**MALLINCKRODT  
NUCLEAR  
CORPORATION**

**SUBJECT:** Extension of SIM-33 to include a Bird Cage for  
Eight Inch Diameter UF<sub>6</sub> Cylinder

**REFERENCE:** Our Letter of July 8, 1960, Subject as Above

Enclosed are sketches SK 7, 7-1, and 9 which should complete the information you require in order to approve the subject request for extension of SIM-33.

BY LJS DATE 8/10/60 SUBJECT BRACKET TO ADAPT SHEET NO. OF  
 CHKD. BY DATE MP CYLINDER BIRD AGE 5K7 JOB NO. 5K7  
TO 8" CYLINDER

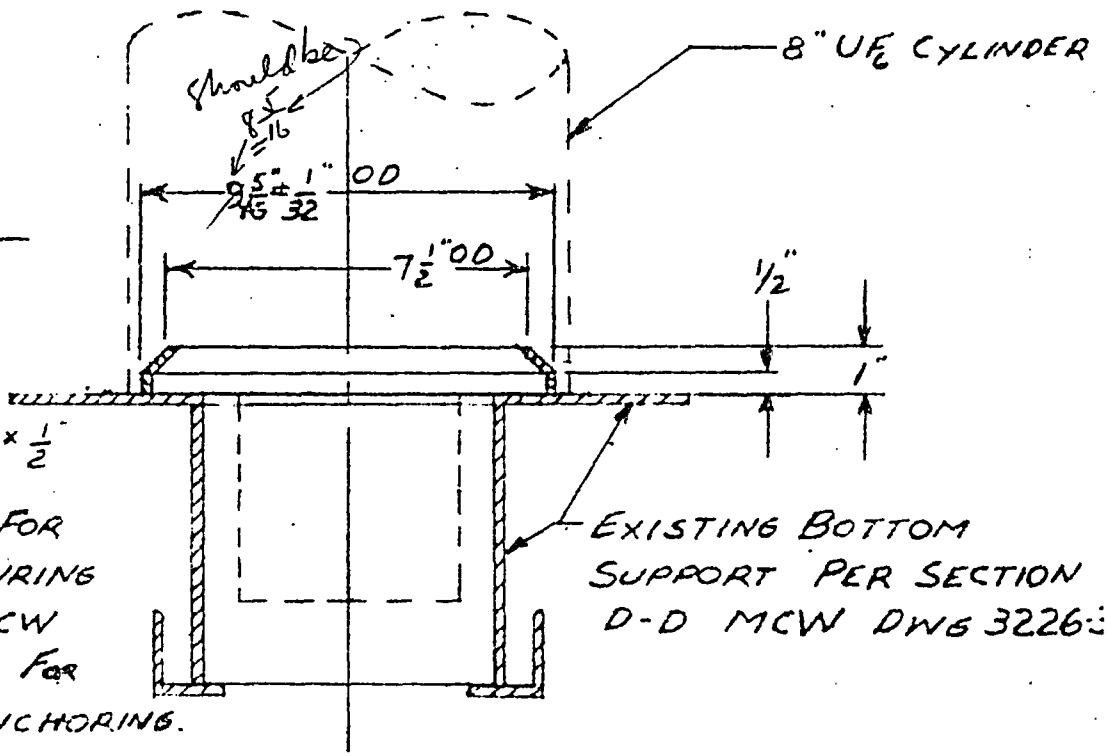
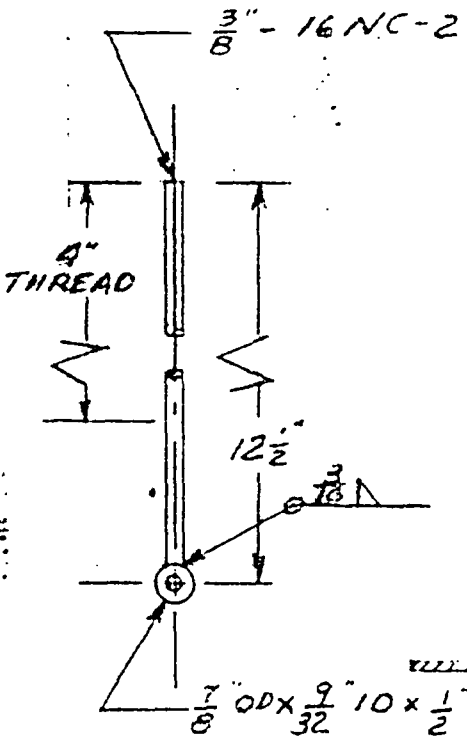
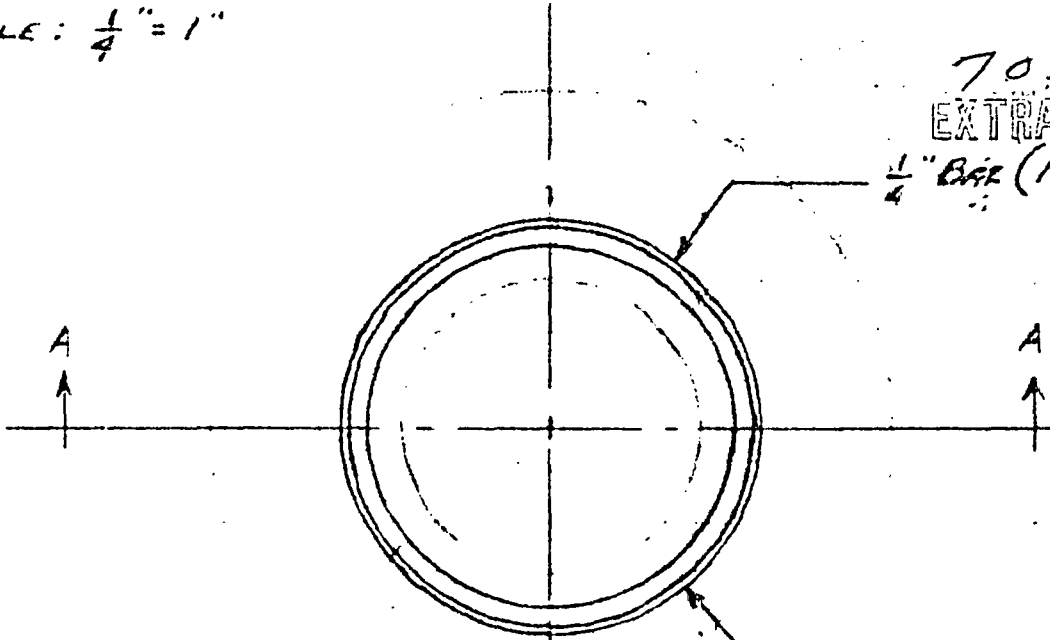
Lateral movement of the cylinder at the top will be prevented by the angle iron bracket shown on SK 7. This bracket consists of two parts. Each part is hinged to the existing framework so that it may be swung out of the way when the larger MD cylinder is shipped.

Finally the cylinder is held down in the same manner depicted in the detail titled "Cylinder Securing Device" shown on MW 3226-3. The only modification necessary is the addition of two 12 1/2 inch long bolts as shown on SK 7-1 with their location shown on SK 7. The existing 6 1/2 inch long bolts will remain for anchoring the MD cylinders.

MOUNT NEW 12½" LONG  
 BOLT FOR CYLINDER  
 SECURING DEVICE PER  
 DWG 3226-3

3½" x 3½" HINGE.  
 SL160 # 1808  
 OR EQUAL

LOCATE NEW 12½" LONG BOLT  
 8" UF6 CYLINDER  
 EXISTING AS PER SECTION A-A  
 MCW DWG. 3226-3

SECTION A-A

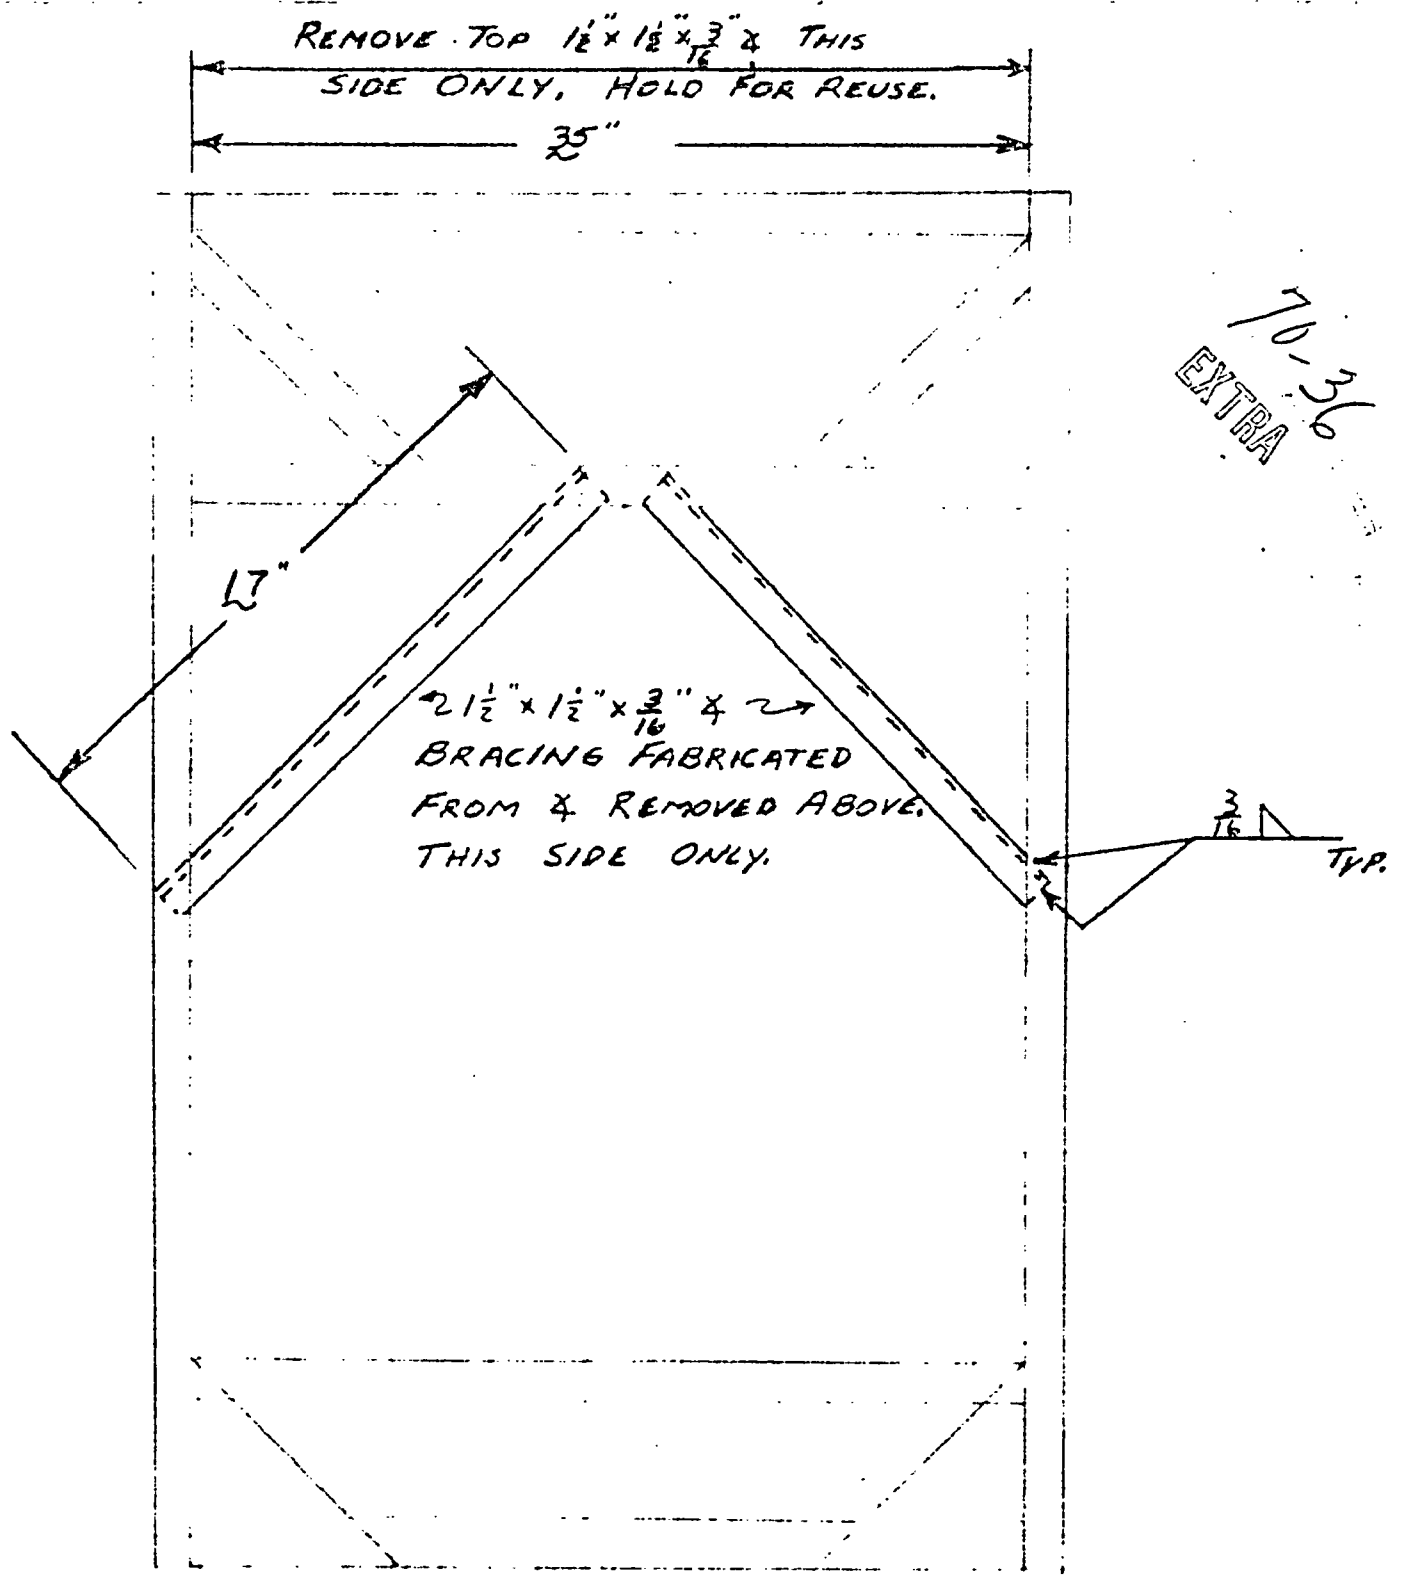
The eight inch UF<sub>6</sub> cylinder will be mounted in the bird cage with the valve end down. The valve cover will be enclosed in the bottom support as shown on SK 7-1. Lateral movement of the cylinder on the bottom support will be prevented by the 1/4" bar added to the bottom support as shown on SK 7-1.

$\frac{1}{4}''$  BRG (NEW)

REVISED BOLT FOR  
CYLINDER SECURING  
DEVICE. SEE MCW  
DWG 3226-3 FOR  
METHOD OF ANCHORING.

EXISTING BOTTOM  
SUPPORT PER SECTION  
D-D MCW DWG 3226-3
